# UNITED STATES PATENT AND TRADEMARK OFFICE

APPLICATION NO.	FILING DATE	FIRST NAMED INVENTOR	ATTORNEY DOCKET NO.	CONFIRMATION NO.
09/142,660	12/23/1998	RAINER HINTSCHE	60953/119	2492

<b>Office Action Summary</b>	Application No.	Applicant(s)	
	09/142,660	HINTSCHE ET AL.	
	Examiner	Art Unit	
	Bradley L. Sisson	1634

## DETAILED ACTION

**Fig. 1**

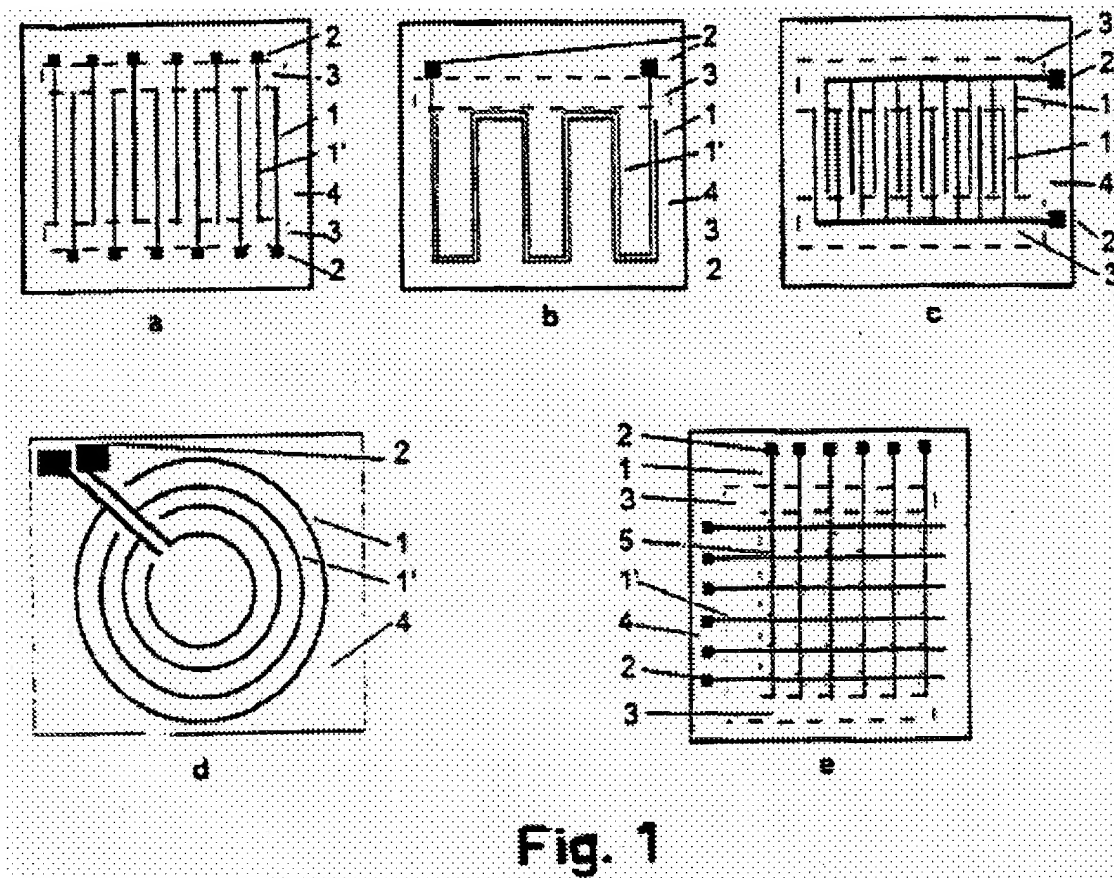
18. The above argument has been fully considered and has not been found persuasive towards the withdrawal of the rejection. The aspect of having multiple apertures arrayed along electrodes, even if the electrode material is continuous, is considered to meet the limitation that there are at least two electrode structures. In support of this interpretation, attention is directed to page 4 of the specification, which is reproduced below in pertinent part.

As can be seen in Fig. 1b, 1c, and 1d, there are but two electrodes present. As is plainly evident above, the ultra-microarray encompassed the very embodiment disclosed by the prior art.
